## EQUUS BEDS GROUNDWATER MANAGEMENT DISTRICT NO. 2

Re: Application No. 45567 – City of Wichita

APPLICATION REVIEW INFORMATION

Figure 9. –  
Application  
No. 45576  
Example of  
Construction  
Design for  
Recharge and  
Recovery Well

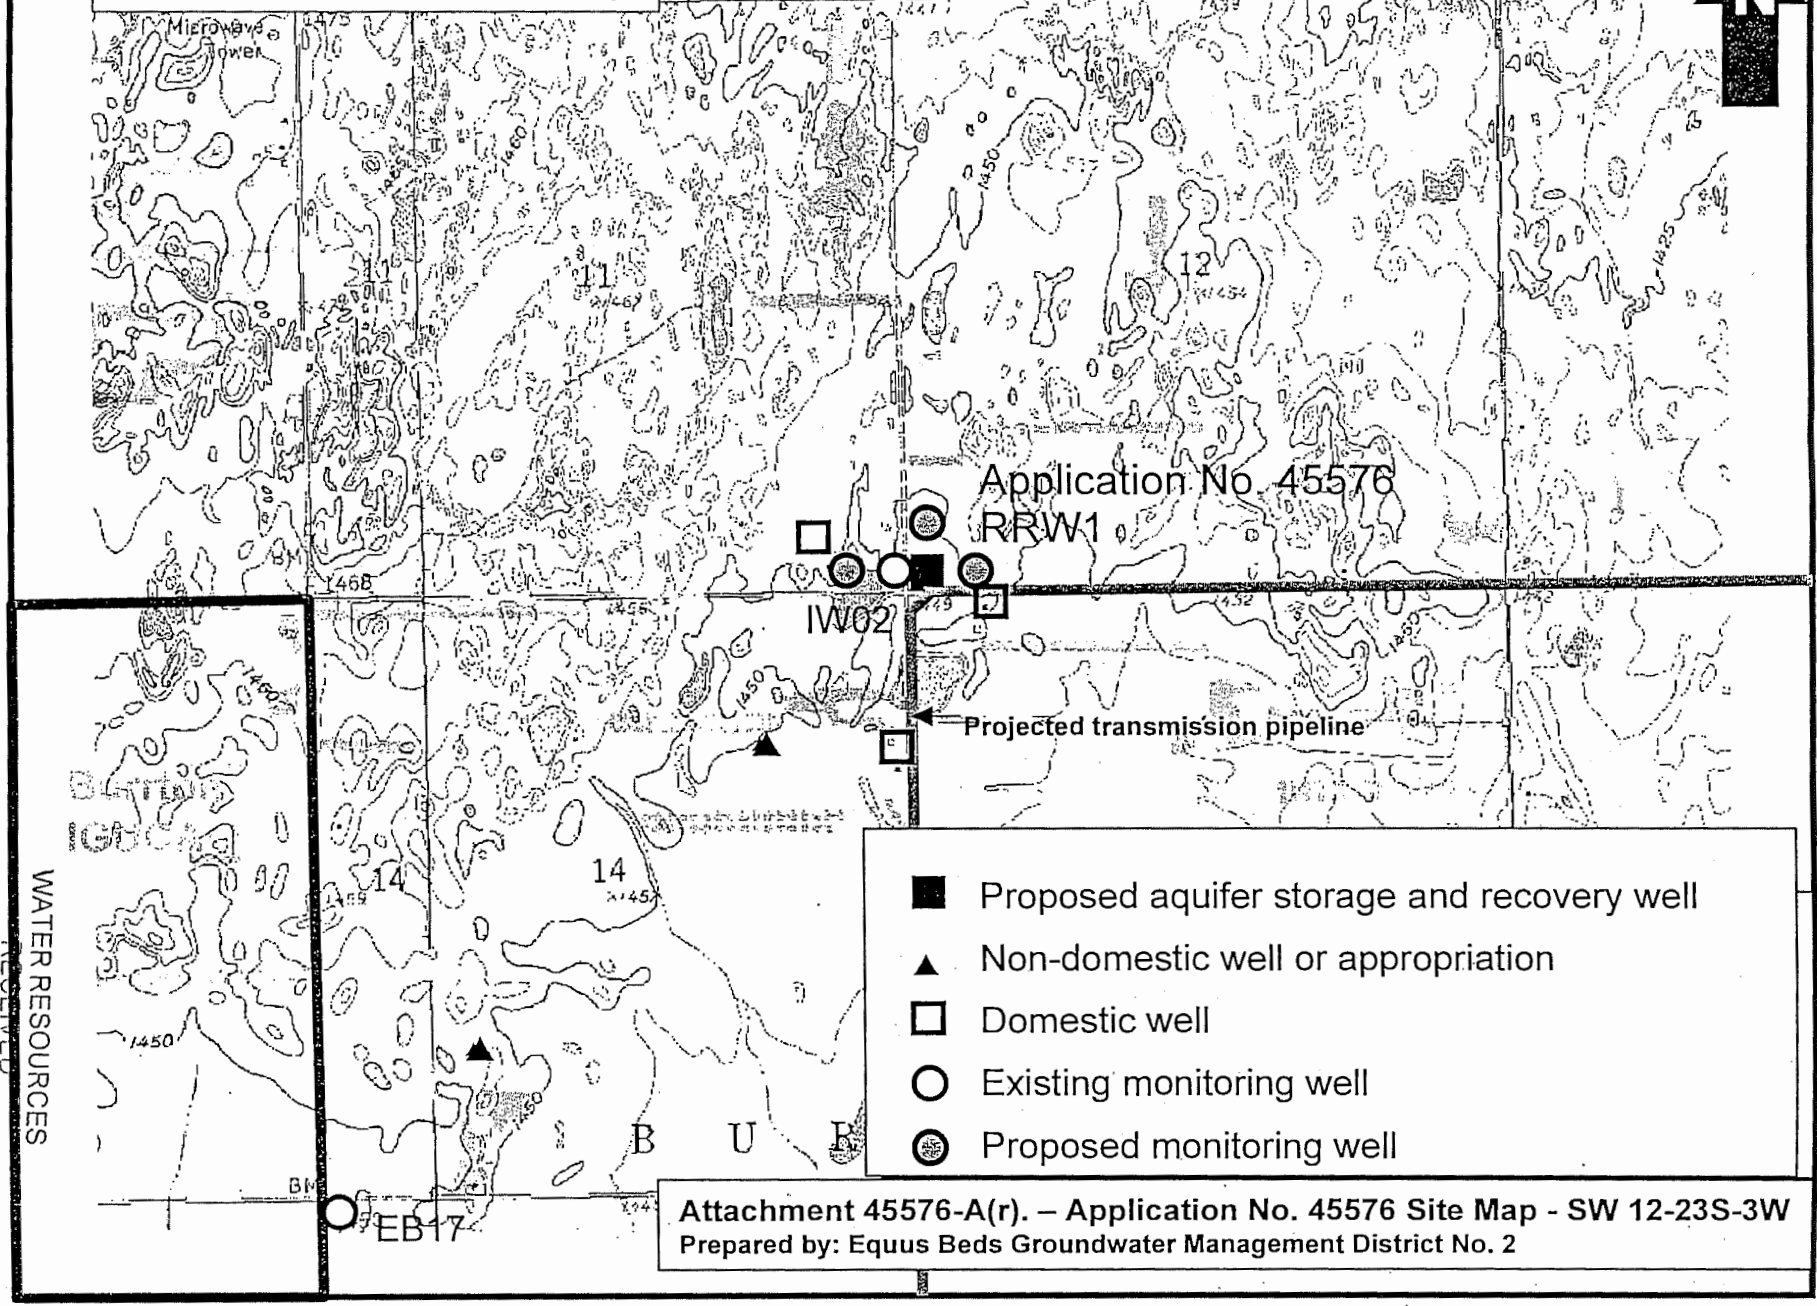
The application's proposed well depth is 124 feet bls to be completed in the lower portion of the aquifer. Proposed well construction specifications were not submitted with the application. An example diagram of recharge and recovery well construction was included in the applicant's demonstration project report (figure 9).
